**SUBJECT: RECALL CAMPAIGN #71004 – (Paxinos, PA Plant only)
2007 & 2008 BOUNDER AND PACE ARROW 38P MODEL –
SLIDE OUT ROOM ELECTRICAL COMPONENT RELOCATION**

RECALL BULLETIN:
71004

SUBJECT:
Relocating
Electrical
Components
and Sealing
Compartment
Containing
Electrical
Controls

Figure 1

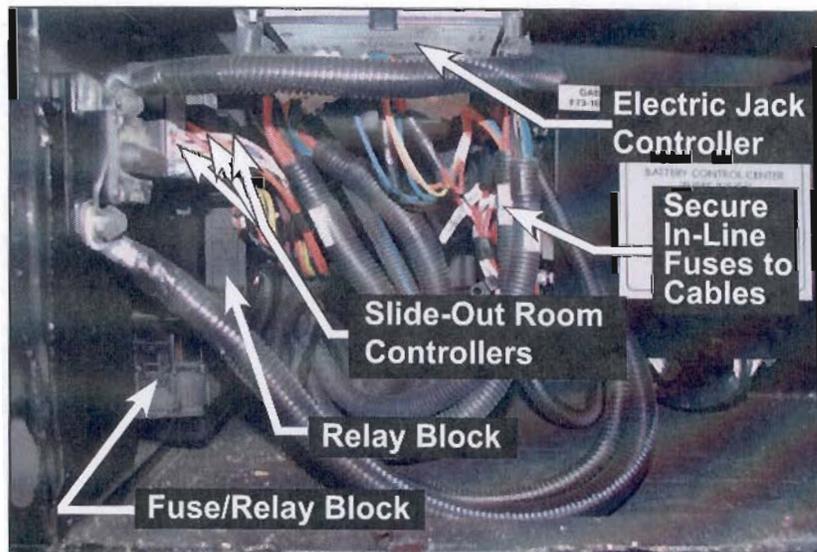
11. Locate an area of the compartment wall that is of sufficient size to re-locate the three slide-out room controllers. Make sure the wiring harnesses will reach to the new location. If sufficient space or wiring harness length is unavailable, it may be necessary to slightly adjust the location of the Fuse/Relay Block within the compartment in order to provide enough area for the slide-out controllers to be mounted. See Figure 1.

12. Locate the relay block inside the electrical compartment containing the Battery Control Center:
 - A. If the relay block is secured above the compartment floor, it does not need to be relocated; skip to Step 14. See Figure 1.
 - B. If the relay block is fastened to the compartment floor, proceed to Step 13 to re-locate it above the floor of the compartment.
13. Locate an area within the compartment that has sufficient size to re-locate the relay block above the floor of the compartment. Make sure the wiring harness will reach to the new location. Secure in place with #8 X 1" Tek Screws or wire ties.

14. Locate the in-line fuses located inside the compartment with the Battery Control Center:
 - A. If the in-line fuses are secured above the compartment floor, they do not need to be relocated; skip to Step 16. See Figure 1.
 - B. If the in-line fuses are located in a manner that they can make contact with the compartment floor, proceed to Step 15 to secure them above the compartment floor.

Figure 2

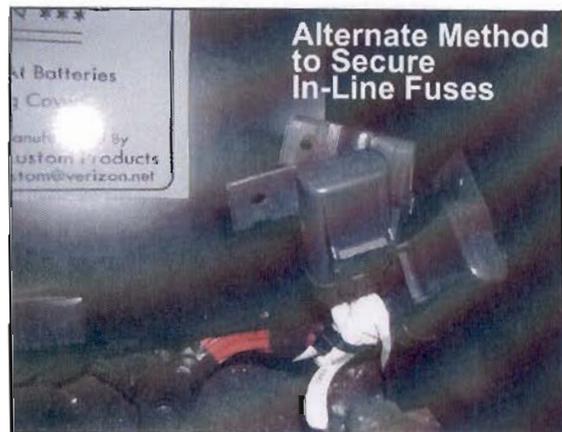
15. If the in-line fuses were determined to need relocation in Step 14, use wire ties to bundle all three fuses together. Relocate the fuses by one of the following methods:
 - A. Use wire ties to secure the in-line fuses to the battery cables connected to the Battery Control Center, making certain that the fuses cannot make contact with the compartment floor. See Figure 1.
 - B. Use a #8 X 1" Tek Screw to attach the mounting tab on one of the in-line fuses to a surface above the floor of the electrical compartment, making sure that all fuses will be elevated off the floor after installation. See Figure 2.
16. Verify that all electrical components are located above the compartment floor; correct as necessary. Proceed to the next section, "Sealing the Compartments".

Figure 5

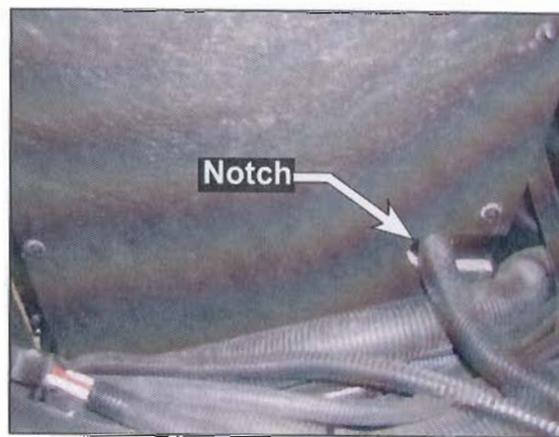
- Use a jigsaw with a fine-tooth blade to make the cuts.
 - Cut openings in the Polyurethane Panel for wire harness routings as necessary. See Figure 5.
 - It may be necessary to trim the Polyurethane Panel in order to achieve a proper fit.
18. Position the new Polyurethane Panel against the bottom flange of the PACO beam, around the PACO Beam Rivet Bracket, and against the bottom of the existing Polyurethane Panel under the Battery Control Center Compartment. Fasten the new Polyurethane Panel using #12-14 x 1" Tek Screws, securing into the bottom flange of the PACO Beam and into the tube steel positioned mid-way toward the rear of the Battery Control Center Compartment. See Figures 4 and 5.

Figure 6

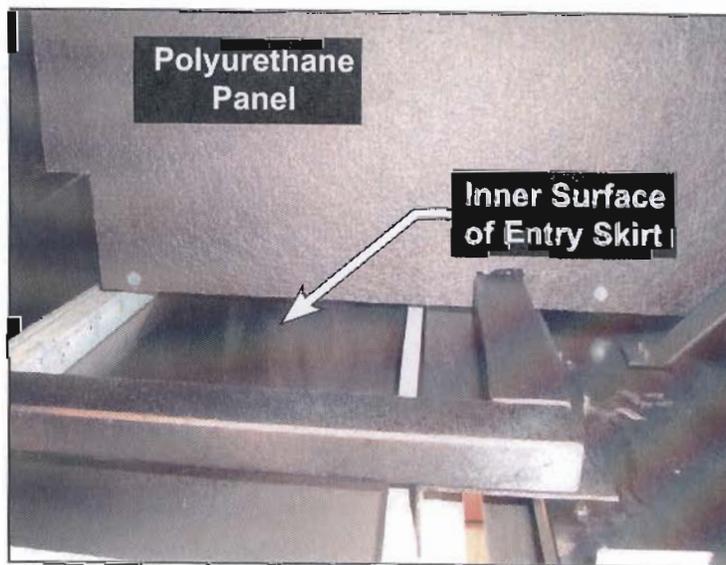
19. Apply SikaFlex sealant to all seams, edges, joints, and any openings for wire harness routings of the newly installed Polyurethane Panels to prevent water intrusion into the compartment area. This needs to include any holes left in the compartment floor as a result of component relocation.
20. Use a dry shop towel to wipe the inner surface of the entry skirt where the Polyurethane Panel, installed during manufacturing, is positioned. This area will be accessible from under the motor home directly below the water fill door. See Figure 6.
